URGENT: MEDICAL DEVICE RECALL

Pipeline™ Vantage Embolization Device with Shield™ Technology

Recall of 027 Compatible Devices (PED3-027-XXX-XX)

Correction (IFU Update) to 021 Compatible Devices (PED3-021-XXX-XX)

Figure 3. Illustration of landing zone and aneurysm neck

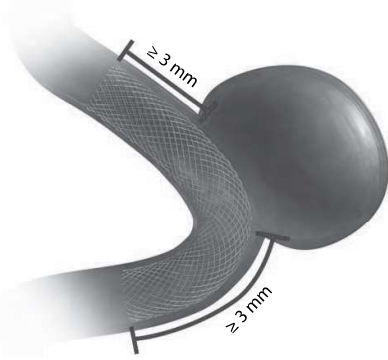
- Choose a Pipeline™ Vantage device with labeled length that is at least 6 mm longer than the aneurysm neck; and ≥ 3 mm landing zone on both sides of the aneurysm neck, see Figure 3.

Verify that the distal and proximal landing zones are both ≥ 3 mm and not under tension, see Figure 3. If less than 3 mm or under tension such that the device may foreshorten in a way that the landing zone is less than 3 mm, consider deployment of an additional device in a telescoping manner, such as an overlapping Pipeline™ or other neurovascular flow-diverting stent to ensure adequate securement of the ends of the implant.

Figure 3 6. Pipeline™ Vantage Embolization Device with Shield Technology™ (Resheathing schematic as seen under fluoroscopy, image not to scale).

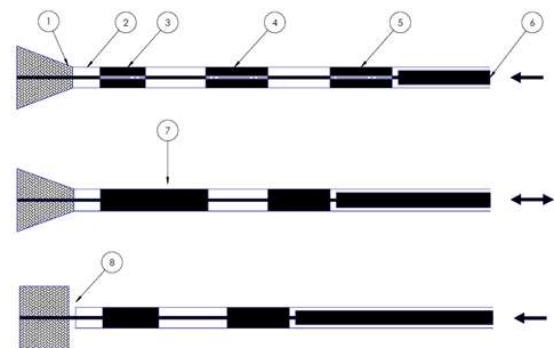
The Pipeline™ Vantage Embolization Device with Shield Technology™ implant is assembled on a guide-wire based delivery system that consists of a 304-stainless steel core wire and a 304L stainless steel hypotube. The implant is assembled over 304 stainless steel resheathing components. A Platinum-Iridium Restraint is distal to the resheathing components and is termed the Resheathing Marker. Refer to Figure 3 6 for the Resheathing Marker position.
